60802 Time Sync – Normative Requirements for d2.1

David McCall – Intel Corporation

Version 1

Table 11 – Error generation limits for Grandmaster PTP Instance

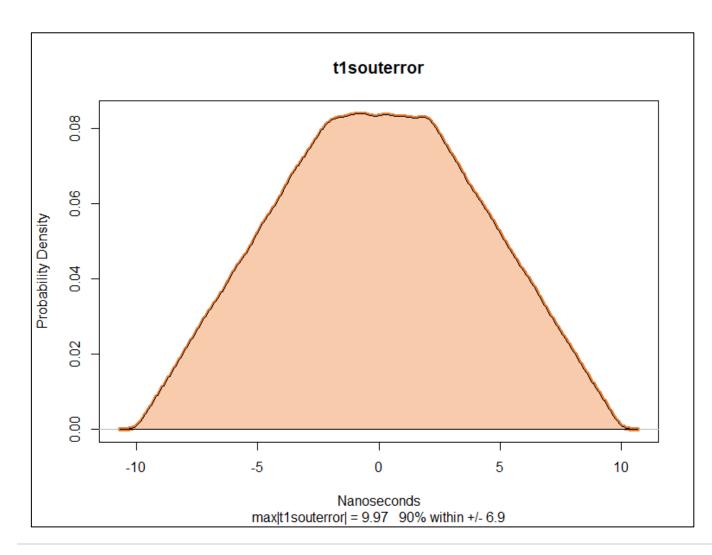
← Includes cTE. Add margin?

← Values need verification

← Does not include cTE.
